ADVANCED COMBAT SOLUTIONS

RE: Reply to Letter Dated July 20, 2016
Request for Additional Information
Application for Sealed Source and Device Registration Certificate and
Application for Distribution of Exempt Products License
Docket No. 030-38926
Mail Control No. 591166

Request for Additional Information Regarding Exempt Distribution License

Request for Additional Information Regarding Sealed Source and Device Registration Certificate

Pic. 1. M16AR15 magazine and location of GTLS

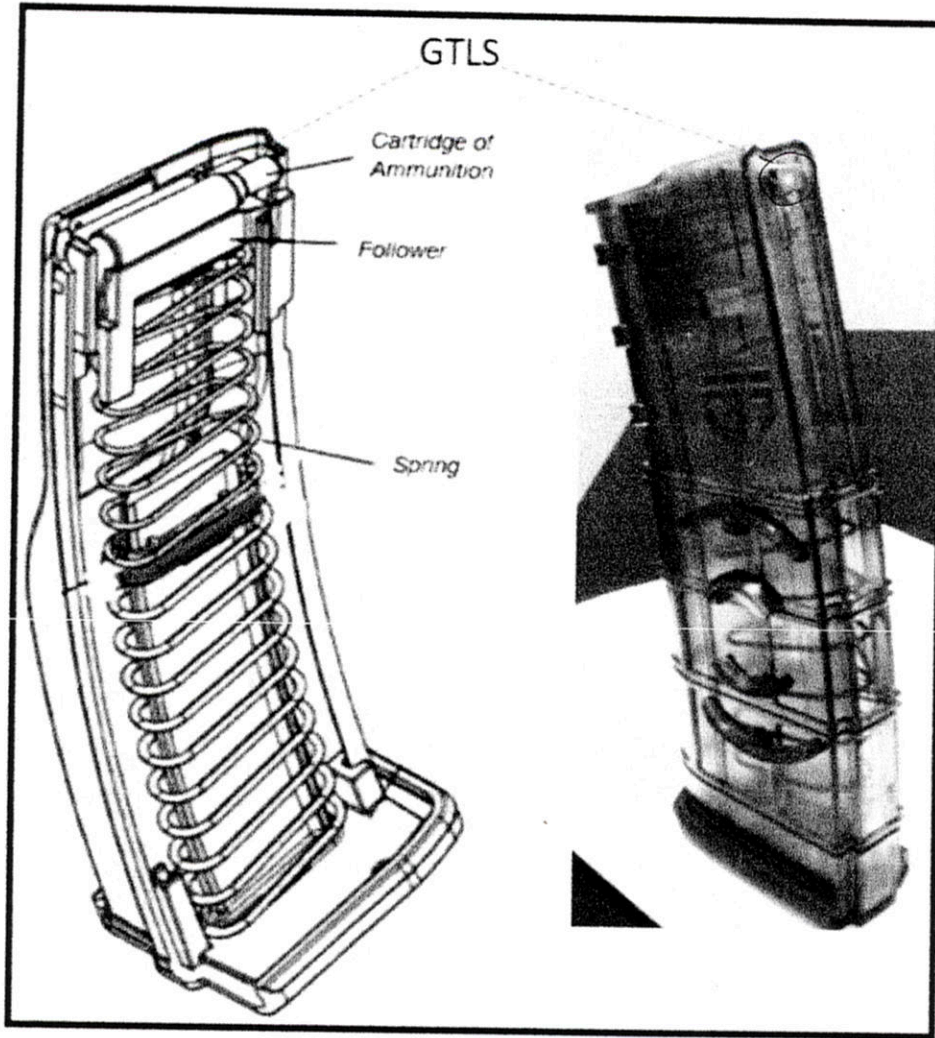
Q#3: Page 5 of the ACS application includes "Pic 1. Firearm Magazine (Cross-sectional view)". On this drawing or a similar drawing, please identify the location of the gaseous tritium light source.

A: Please see below Pic. 1.

Pic. 2. LEMI Model to be used for Glock handguns

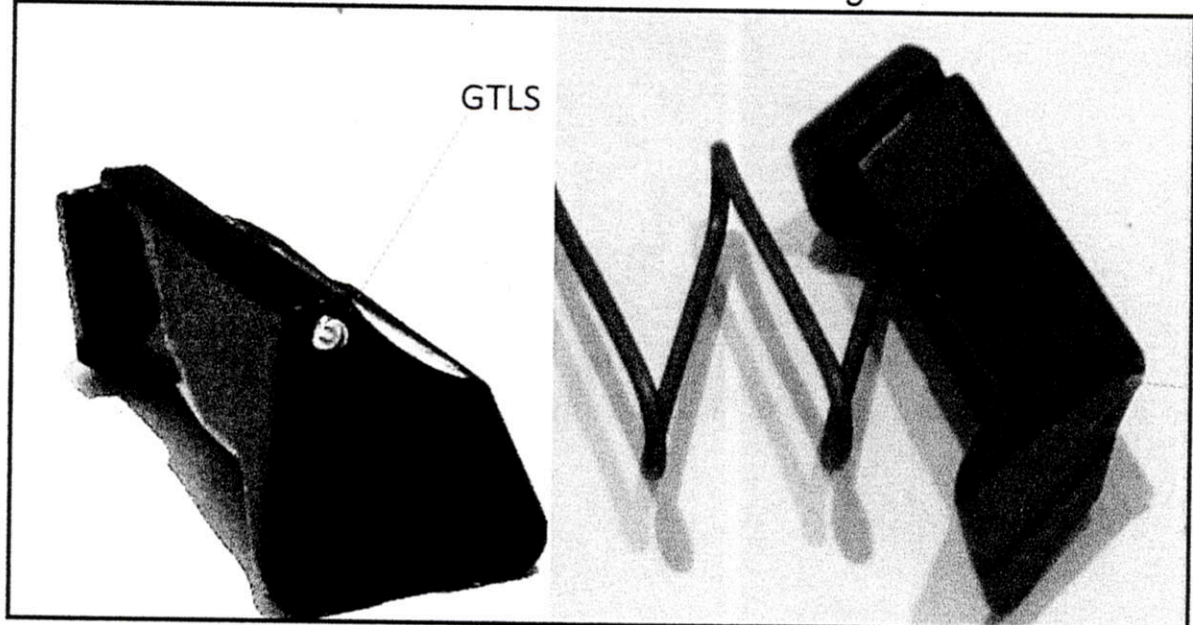
Q#6: Please provide a picture of the LEMI model that will be used for Glock handguns similar to "Pic. 2" provided on page 6 of the ACS application.

A: Please see below Pic.2

Pic.4. M16AR15 Follower and parts of the follower subject to pressure from the spring

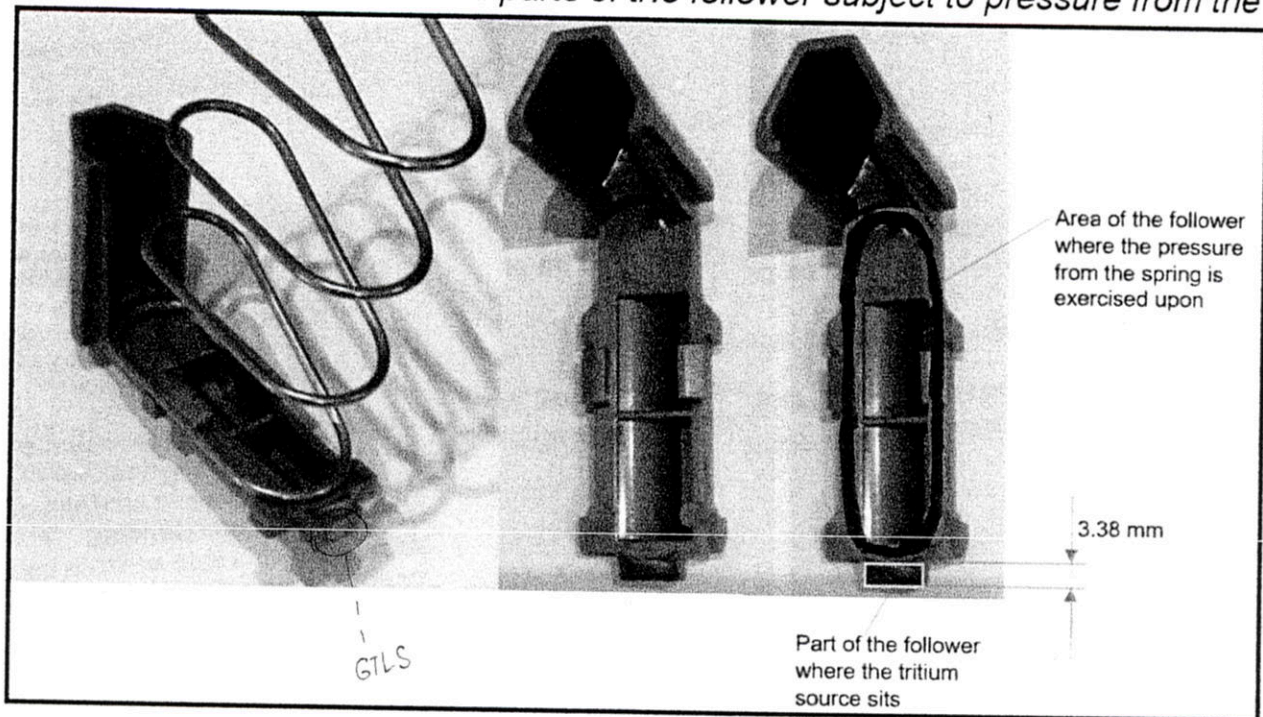
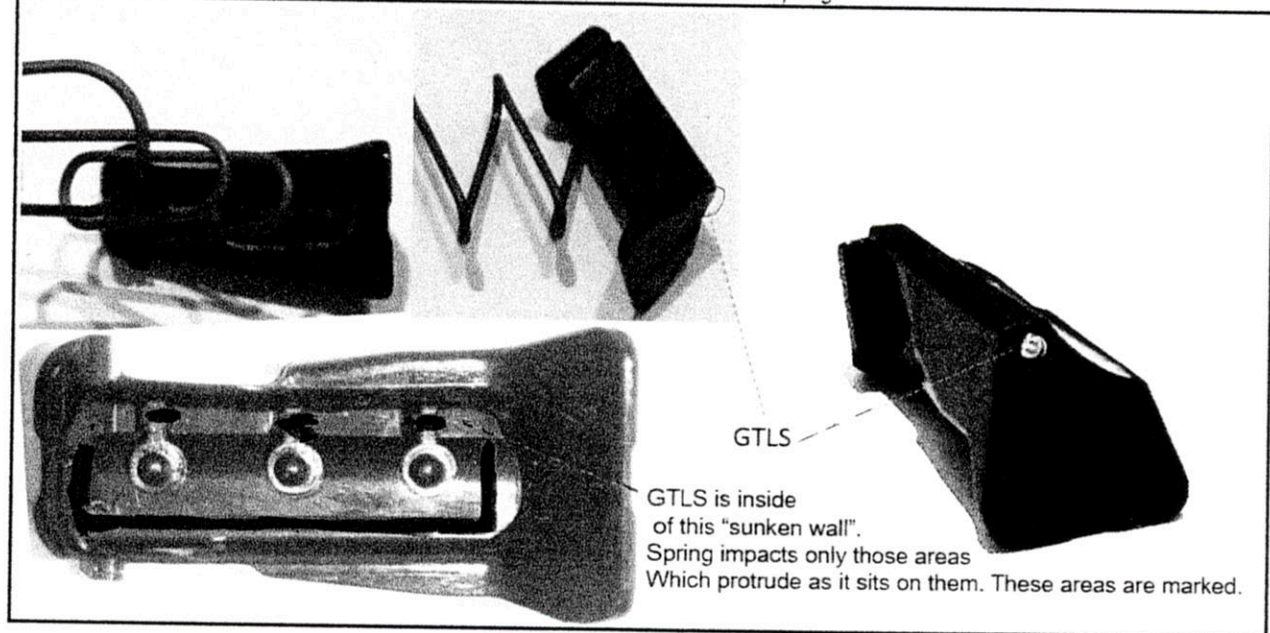
Q#8: The LEMI Series devices will be attached to a spring in a semi-permanent manner and will provide opposite force against the weight of the ammunition being forced up and out of the magazine body. Please explain how the prototype testing performed on the LEMI Series demonstrate that the device will maintain its integrity during normal conditions of use and accidental conditions through the useful life of the devices. Specifically, please explain how the testing is representative of the impact forces and compression the device will receive during its useful working life of 12 years.

A: Opposite force coming from the spring pressing the follower against ammunition is applied at its maximum to the area of the follower marked below (Pic. 4 – Pic. 5).

Pics. 4 - 5 above prove that the tritium source is not under direct compression and impact effects from the spring.

Maximum pressure exercised by a brand new spring in its fully compressed position against any surface (in our case, the follower followed by a stack of cartridges) is on the area of contact with the follower (marked on Pics.4-5), and is approx.20 psi for M16AR15 magazine spring (and circa 12 psi for Glock magazine spring) (measured with the scale "Mini crane scale. Model: OCS-L). It is important to note that the spring's energy potential decreases over time and is inversely proportional to its increased use. Therefore, with continual use the spring's ability to exert opposing force against the captive weight of cartridges contained within the magazine body lessens over time.

Pic.3. ICSI and friction explained in regards to different parts of ICSI

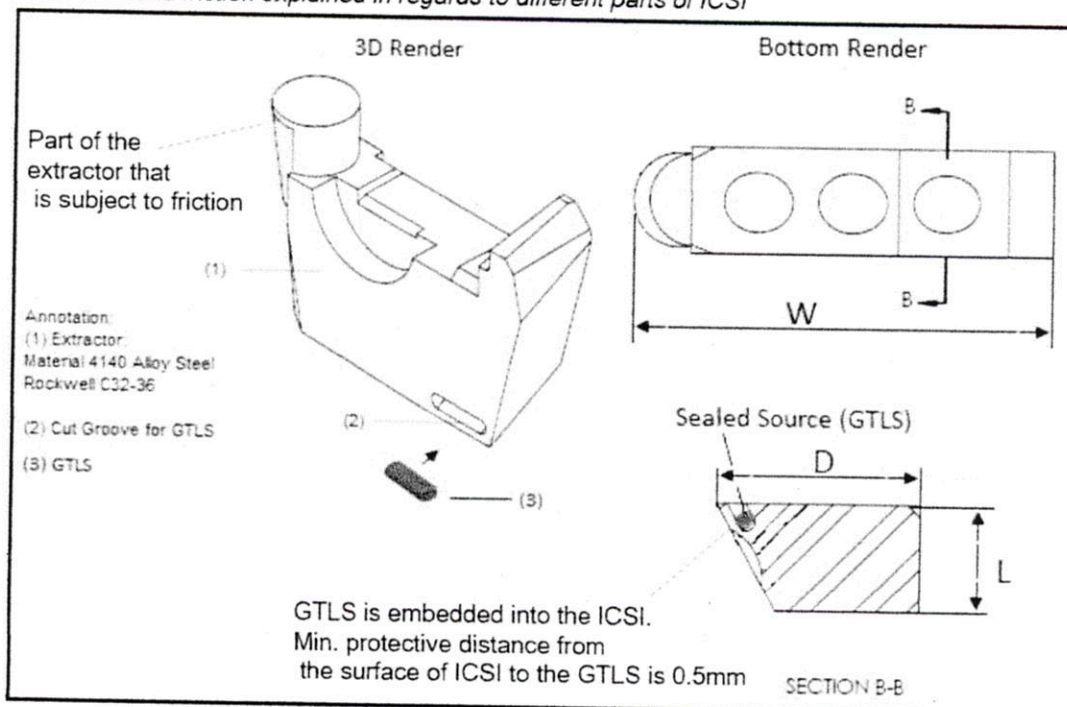
Q#9: The design of the ICSI extractor suggests that it is likely to be regularly subjected to friction. Please demonstrate that the source will remain in the device during its useful working life when submitted to repetitive friction.

A: The ICSI extractor may visually appear to be a component within the firearm that is under constant frictional forces. However, this is true only to a small part of the ICSI: the area of the ICSI extractor that undergoes any friction is the pivot-arm looking part of the ICSI extractor assembly. It is easily recognizable in the drawings as it has a conical shape. Furthermore, the area in which the tritium lamp is located in the ICSI assembly is at the diagonally opposite end, so at the furthest distance from where the source of friction is occurring. Moreover, the tritium source is located below the surface and embedded into the ICSI extractor which then literally encapsulates and protects it from any direct contact, including any friction. Due to the design and materials used in the construction of the ICSI, the tritium source will persist in a condition that is fully removed from any friction or direct contact of any kind while in use for the full life of the weapon.

Please also see Pic.3 for a visual representation of what is explained above.

Pic.7. Examples of Labeling: ICSI Series, LEMIM16AR15 Series and LEMIGLK Series

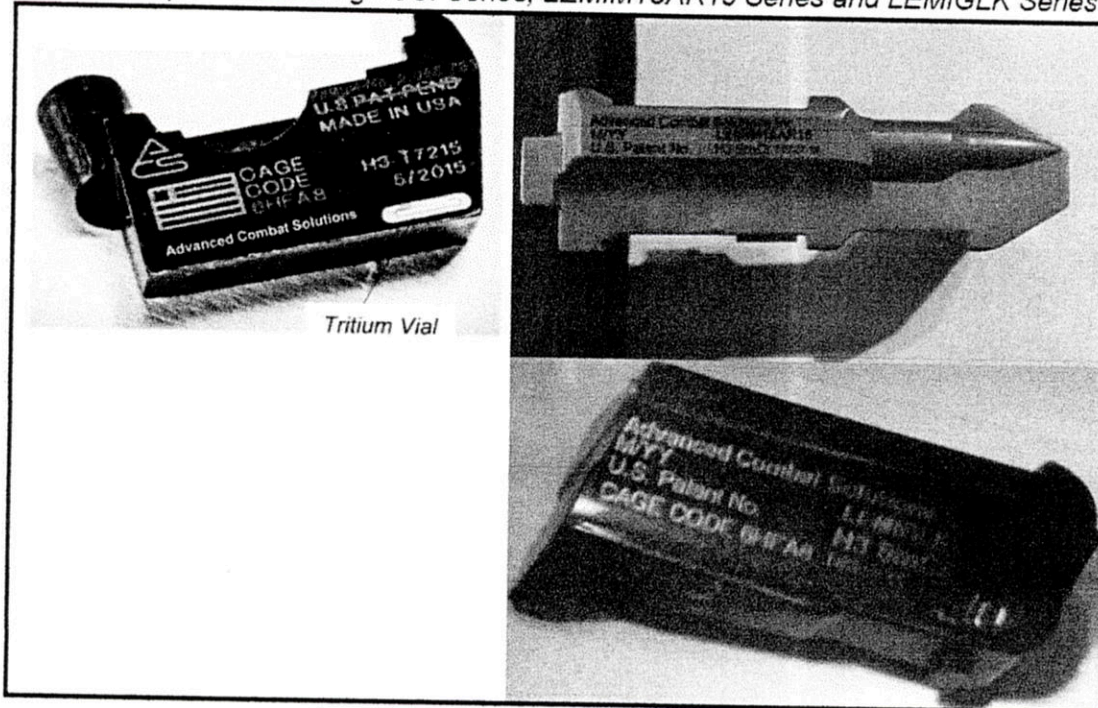
Q#10: Page 9 of the ACS application includes examples of the information that will appear on the LEMI and ICSI labels. Please note that the company logo may not be sufficient to meet the requirements for labeling as described in 10 CFR 32.22 as an identification of the manufacturer. In order for a logo to be an acceptable method to identify the manufacturer the logo must be a Registered Trademark. If the logo is trademarked or registered please provide information to support that the trademark has been registered. If the logo is not registered please provide a new method of identifying the manufacturer: this could include the entire name of the Exempt Distribution License number that will be issued by the NRC.

Q#11: Please provide a picture of the LEMI Series that includes the label.

A: Thank you. Well noted. We will laser etch the complete name of the company then ("Advanced Combat Solutions" as in the Pic. 7 below).

A: Please see the Pic. 7 below.

Dimensions are in mm	Version 1.0	LEMGLK	
Tolerances:		Date: 1 Aug 2016	Drawing # ACS-0011
Fractions: +/- 1/32		Sheet: 1 of 1	
.xx +/- 0.05		Title	Comprehensive View
.xxx +/- 0.005			Render
Angles: +/- 1 Deg.

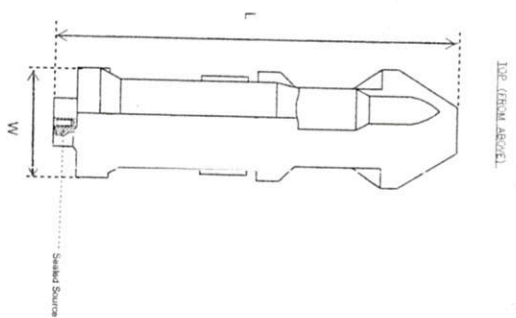
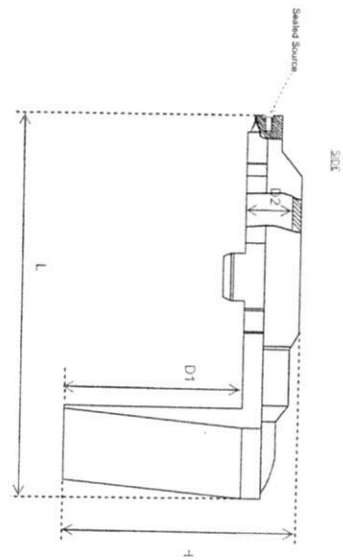
Q#4: The application requested the evaluation of the LEMI Series. Please provide the maximum and minimum dimensions for the models in the LEMI Series. Please indicate if the installation of the source varies per model.

Q#5: Please provide drawings that include the overall dimensions, i.e. length, width, and height of the LEMI Series for the Glock and M16AR15 configurations and the ICSI device.

Q#12: Please provide a drawing for the LEMI Series showing the location where the source will be installed.

A: please kindly see the tables in Attachment 2 (LEMIGLK Series) and Attachment 3 (LEMIM16AR15 Series) that provide min and max dimensions. Method of the installation and location of the source is the same for every model. What differs for every model is the type of the source (the source types are presented in Enclosure C to the Application).

A: Please see Attachment 2 – 3 for LEMI Series and Attachment 4 for ICSI Series.

A: Please see Attachments 2-3.
